## HISTORIC AND DESIGN REVIEW COMMISSION

**HDRC CASE NO:** 2019-544  
**ADDRESS:** 302 ADAMS ST  
**LEGAL DESCRIPTION:** NCB 946 BLK 2 LOT 10,11 EXC SW TRI 15.90 FT & NE TRI 12.3 FT OF 12  
**ZONING:** RM-4, H  
**CITY COUNCIL DIST.:** 1  
**DISTRICT:** King William Historic District  
**LANDMARK:** Meerscheidt, Paul / Davis - House  
**APPLICANT:** Daniel Sexton/Buffalo Contracting Services  
**OWNER:** Beverley Bunn/QUEEN B PROPERTIES LLC  
**TYPE OF WORK:** Installation of rear concrete parking pad  
**APPLICATION RECEIVED:** September 10, 2019  
**60-DAY REVIEW:** October 09, 2019  
**CASE MANAGER:** Huy Pham  
**REQUEST:**

The applicant requests a Certificate of Appropriateness to install a 700 square foot concrete parking pad at rear of historic structure, adjacent to existing driveway.

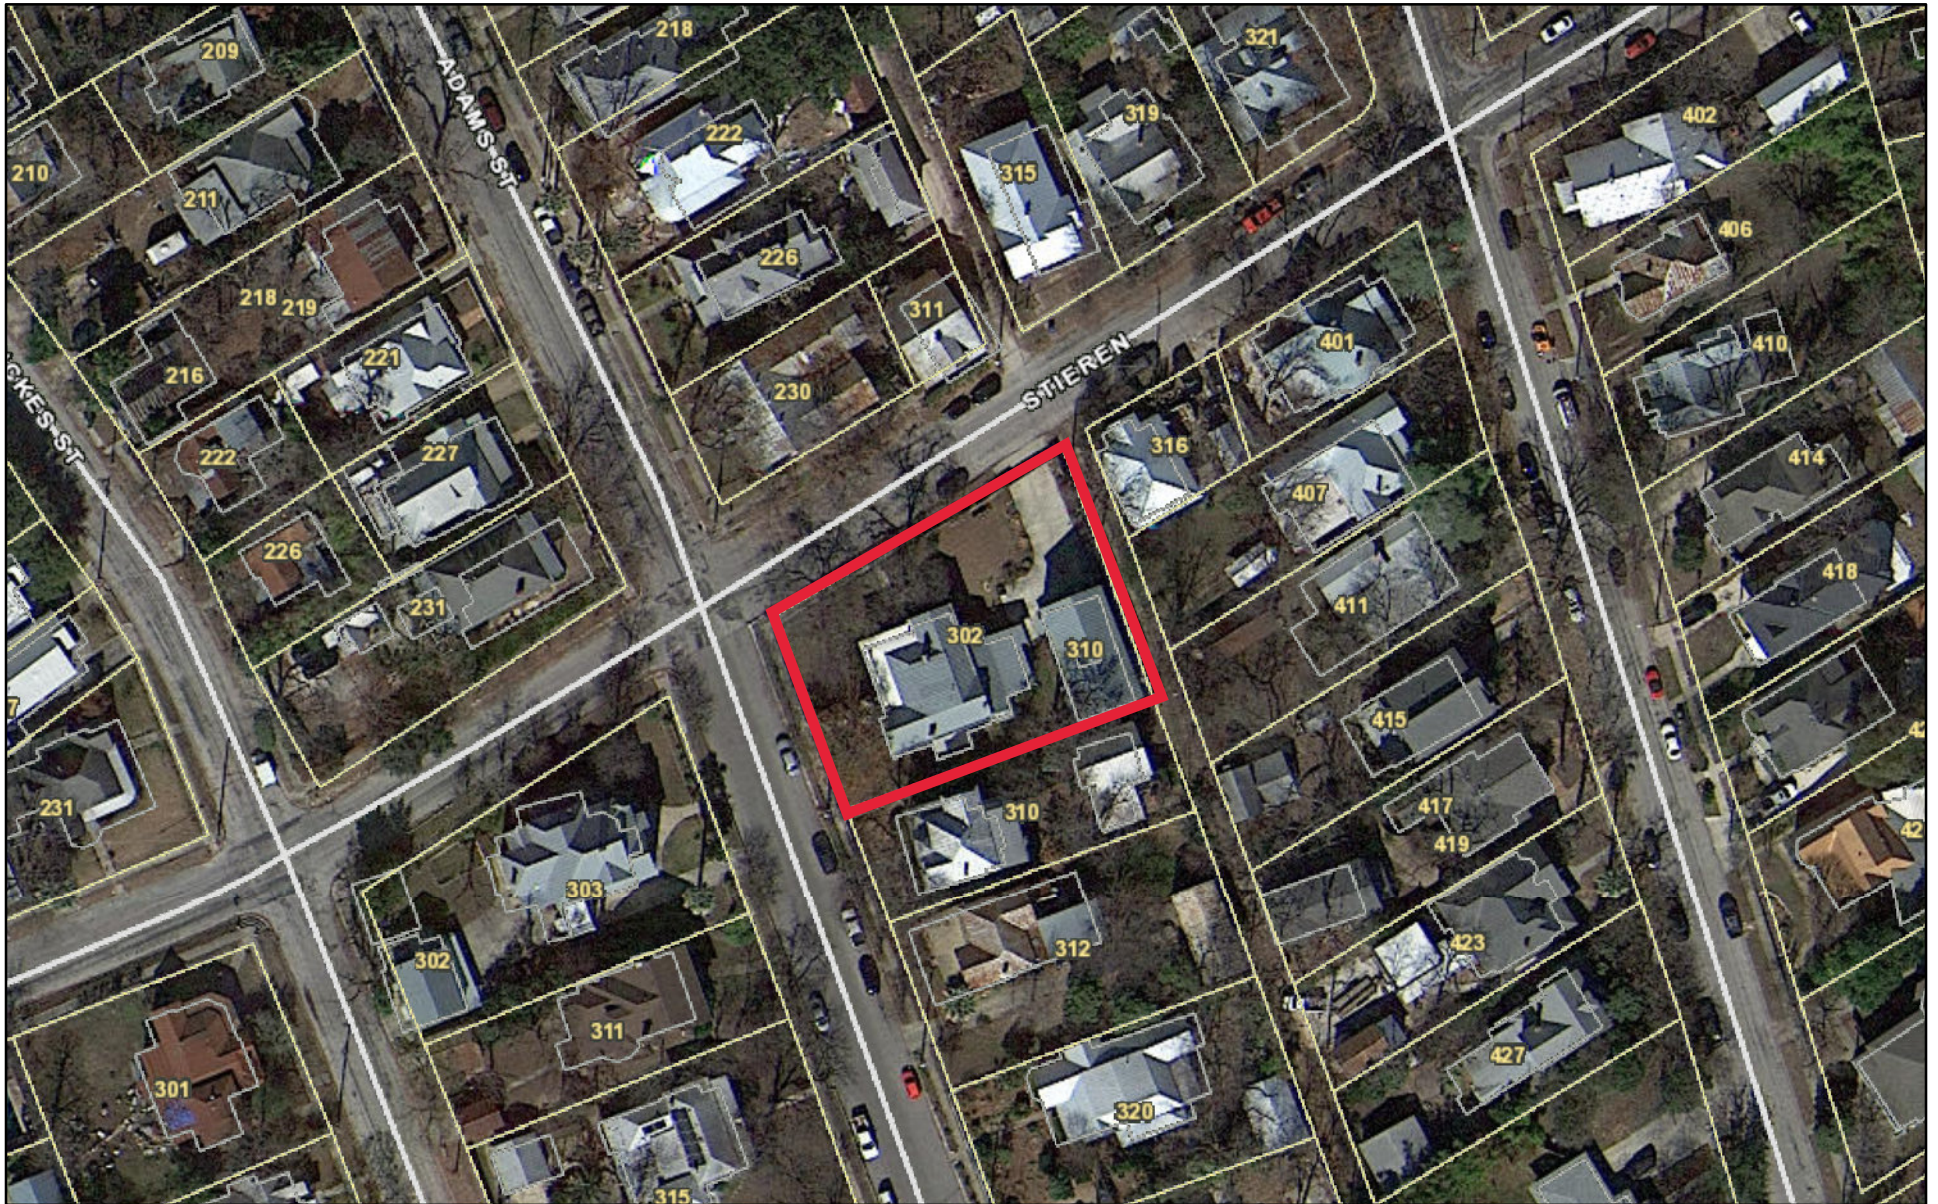
- a. The property at 302 Adams features a primary historic brick structure and a non-historic composite structure in the rear yard. The rear yard features a 24 foot concrete apron tapering to a 20 foot driveway behind the privacy fence.

- b. **DRIVEWAY** – The applicant has proposed to install a 25’ x 28’ (700 square feet) parking pad attached to the existing 20’ wide concrete driveway in the rear yard. Per the Guidelines for Site Elements 5.5.B.i., applicant should incorporate a similar driveway configuration—materials, width, and design—to those historically found on the site; historic driveways are typically no wider than 10 feet. Staff finds that the visual site design is mitigated by locating the parking pad in the rear yard and behind a privacy fence. The Guidelines, however, also note that pervious paving surfaces should be considered where replacement is necessary to increase storm water filtration. Staff finds that the concrete parking pad addition as proposed would feature nearly half of the rear yard as impervious cover and should instead feature a pervious surface such as crushed granite, gravel, or “grass-crete”.

Staff recommends approval based on finding b with the stipulation that the new parking pad features a pervious material such as crushed granite, gravel, or “grass-crete”; design and material updates should be submitted to staff prior to final approval and installation.
